Technical Evaluation Report

REVIEW OF  
RESOLUTION OF KNOWN PROBLEMS  
IN ENGINE COMPONENTS  
FOR TRANSAMERICA DELAVAL INC.  
EMERGENCY DIESEL GENERATORS

December 1985

Project Title: Assessment of Diesel Engine  
Reliability/Operability

**FIGURE 4.3.1.** Connecting Rod, Model R-4 Inline Engine  
Source: Failure Analysis Associates  
(June 1984, p. 1-4)

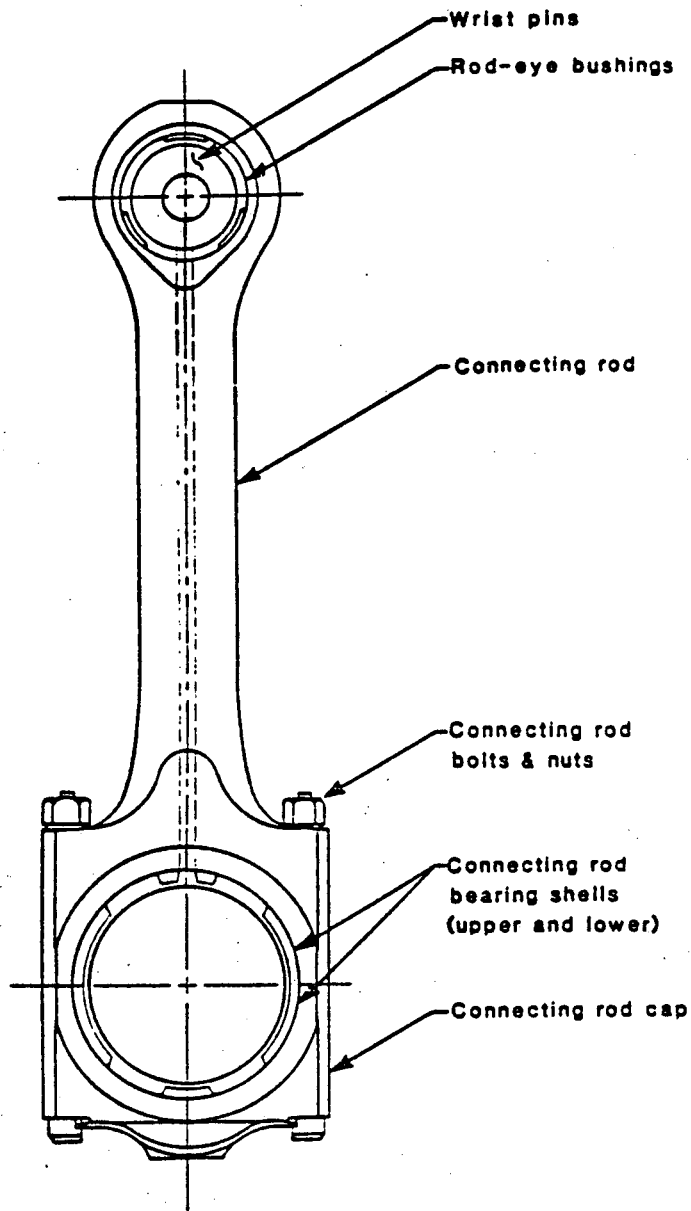
Based upon review of the documentation cited previously, PNL concurs with the Owners' Group that the DSR-48 connecting rods are adequate for their intended service in emergency diesel generators for nuclear power plants. PNL also concurs with the FaAA recommendation that linear indications in the rod-eye bushing are not acceptable within  $\pm 15$  degrees of the bottom dead center position. Further, PNL concurs with FaAA that cracks deeper than 0.04 inch in the rod eye are not acceptable, nor are cracks acceptable at the root of the connecting rod bolt threads.

- All connecting rod bolts, nuts, and washers should be visually inspected during each major (5-year) engine disassembly, and damaged parts should be replaced. The bolts should be magnetic-particle (MT) inspected to verify the continued absence of cracking. For future bolt inspections, PNL recommends the wet-fluorescent MT technique, which will provide the enhanced sensitivity normally specified for bolt examinations. No detectable cracks should be allowed at the root of the threads.

- During any disassembly that exposes the inside diameter of a rod-eye bushing, the surface of the bushing should be examined with liquid penetrant to verify the continued absence of linear indications in the heavily-loaded zone within  $\pm 15$  degrees of the bottom dead center position.

**FIGURE 4.4.1.** Connecting Rod, Model RV-4 V-Engine

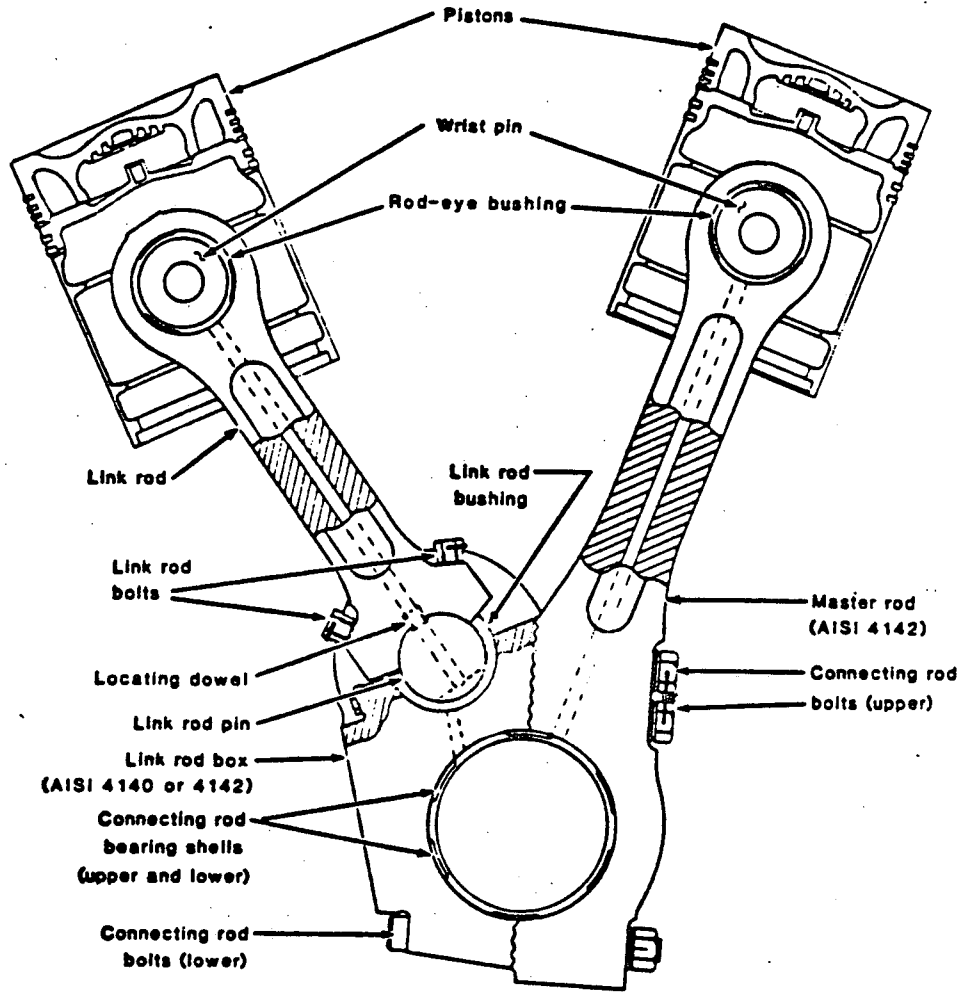
In the opinion of PNL's reviewers, FaAA's two-dimensional finite element analysis and FaAA's fracture mechanics analysis do not, by themselves, provide a conclusive basis for determining the adequacy of the connecting rods for their intended use in standby diesel generators for nuclear power plants. As discussed in FaAA-84-3-14, the predicted peak stresses are slightly below the fatigue initiation curve for connecting rods with 1-1/2-inch bolts and slightly above the fatigue initiation curve for connecting rods with 1-7/8-inch bolts. Also according to the FaAA report, strain-gage testing of a connecting rod with 1-1/2-inch bolts shows that cyclic and mean stresses are lower than those predicted by analysis. However, the differences are not quantified in the report. Considering the approximate nature of the calculated stresses and the unknown level of conservatism of the analyses, PNL's reviewers cannot draw unequivocal conclusions from the results.

Subject to the recommendations discussed later in this section, PNL concurs with the Owners' Group that the DSRV-4 connecting rods are adequate for their intended service in emergency diesel generators for nuclear power plants. PNL's recommendations concern additional surveillance of the connecting rods to facilitate the timely identification of any problems that may develop in service. In PNL's opinion, the additional surveillance is necessary in light of

- All connecting rod bolts should be visually inspected for thread damage (e.g., galling), and the two pairs of connecting rod bolts above the crankpin should be MT inspected to verify the continued absence of cracking. PNL recommends the wet-fluorescent MT technique as discussed above for the preservice inspections of the bolts. All washers used with the bolts should be examined visually for signs of galling or cracking, and replaced if damaged.

- A visual inspection should be performed of all external surfaces of the link rod box to verify the absence of any signs of service-induced distress.
- All of the bolt holes in the link rod box should be inspected for thread damage (e.g., galling) or other signs of abnormalities. In addition, the bolt holes subject to the highest stresses (i.e., the pair immediately above the crankpin) should be examined with an appropriate nondestructive method to verify the continued absence of cracking. Any indications should be recorded for engineering evaluation and appropriate corrective action.

**FIGURE 4.7.1.** Variation of Free-End Crankshaft Vibration with Engine RPM for Sum of 24 Orders in TDI DSRV-16-4 Crankshaft

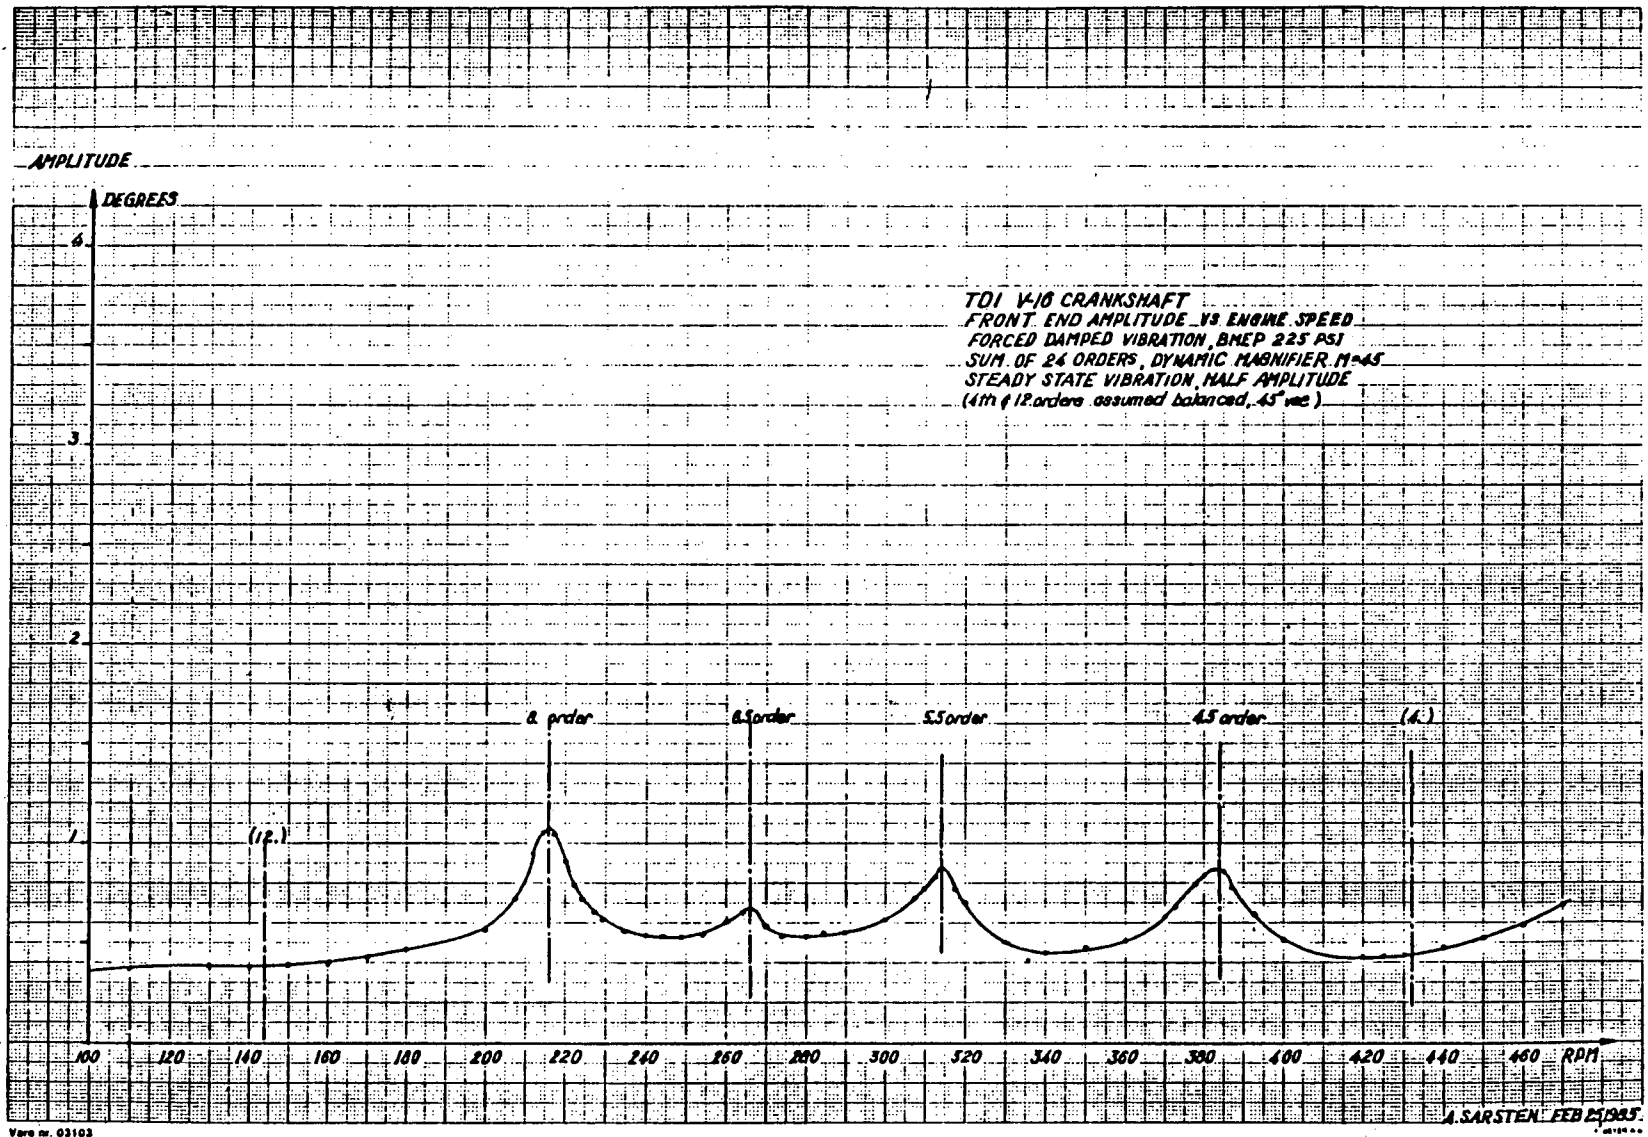
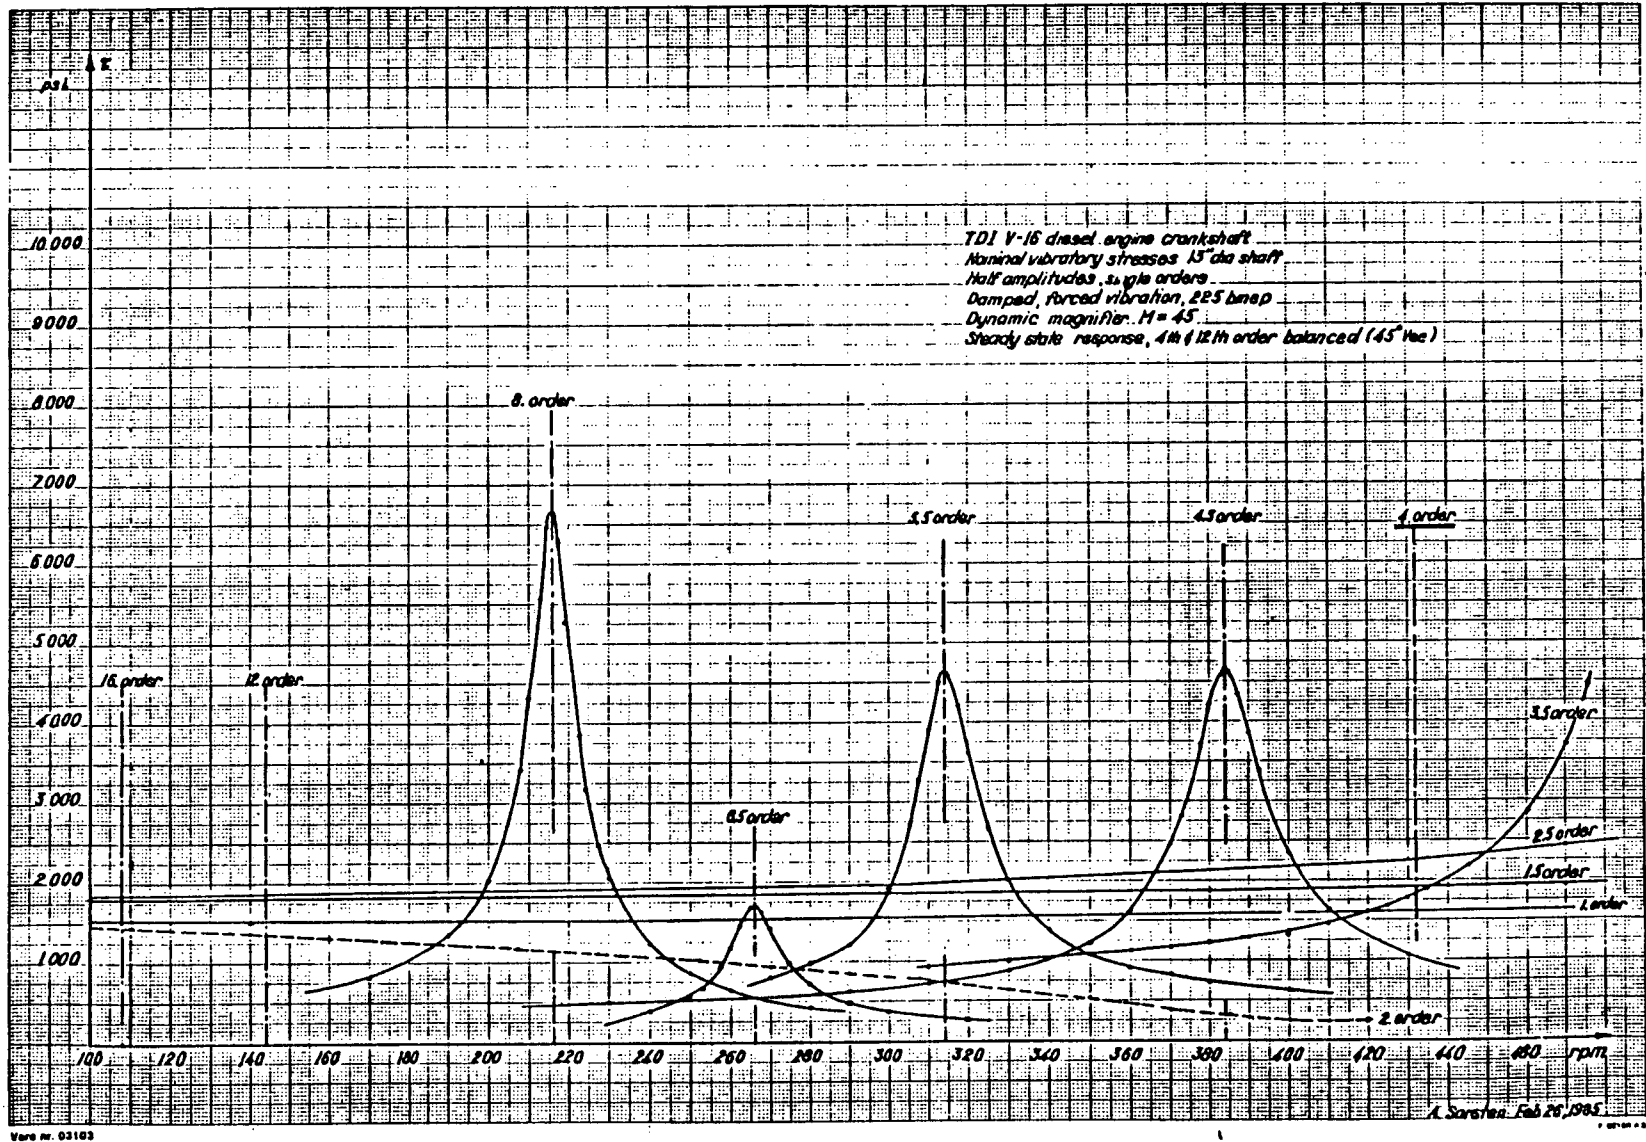
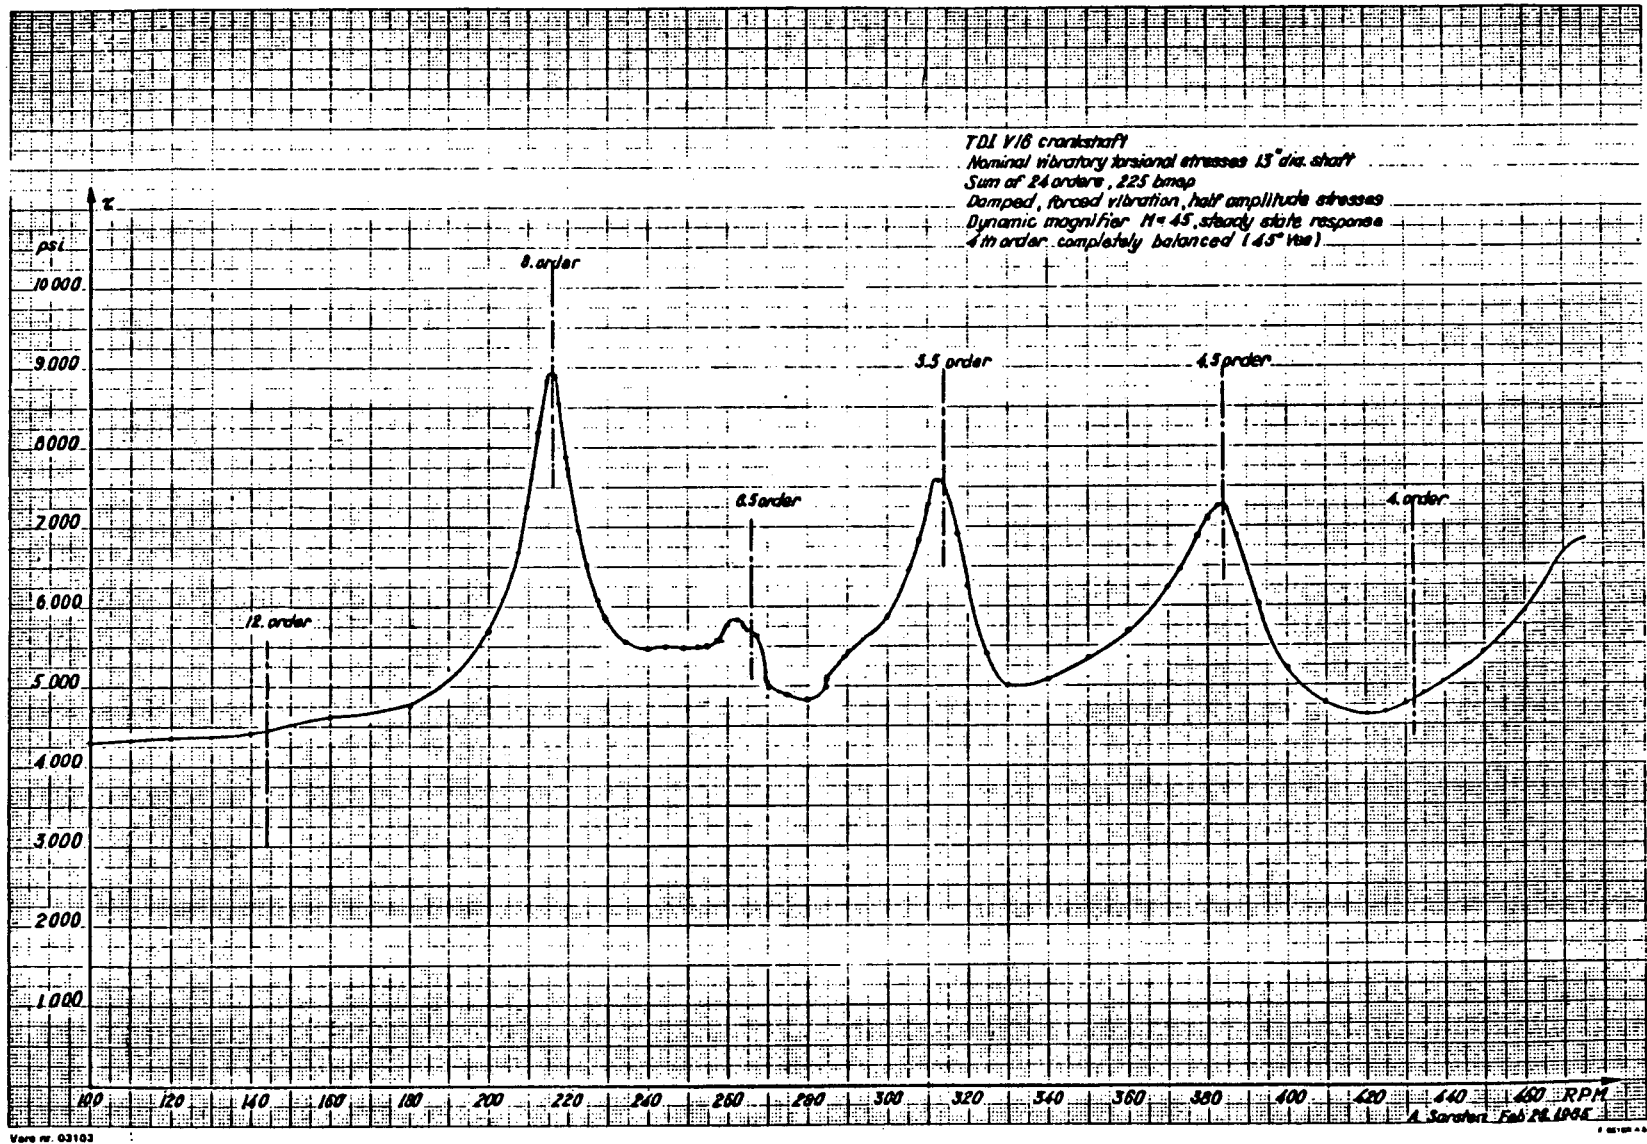
Prof. Sarsten made the following observations on the results summarized in Figures 4.7.1 through 4.7.3:

- The resonant peaks at speeds corresponding to orders 4.5, 5.5, 6.5, and 8 are not closely spaced, and therefore would not be expected to augment each other during engine startup. The vibratory conditions associated with these resonances are acceptable for engine acceleration through this speed range. No significant resonances of higher modes were detected in the speed range investigated.

- No responses are shown for the 4th and 12th orders, because these orders vanish under the assumptions used in the analysis. The excitations of these orders from one bank of the V-engine cancel the excitations from the other bank, assuming the cylinders are evenly balanced and disregarding the effect of the articulated connecting rods on piston motion and timing. However, the 4th order in the actual engine is important because it occurs within -5% of the rated engine speed. Any lack of uniformity in the pressure diagrams of individual cylinders will excite this order, as will the slightly different piston motions and timing associated with the articulated connecting rods.

PNL notes from FaAA's torsigraph tests of the engines at Perry and Comanche Peak (Sections 4.7.5 and 4.7.7) that the maximum transient responses measured during startups and coastdowns produce nominal stress amplitudes well below the maximum resonant stress predicted in Prof. Sarsten's analysis (i.e., the 8th-order response of 8900 psi at 217 rpm, plotted in Figure 6.4.3). Thus, the torsigraph test results confirm that peak stresses under normal transient conditions are lower than the peak resonant stress predicted from Prof. Sarsten's steady-state analysis.
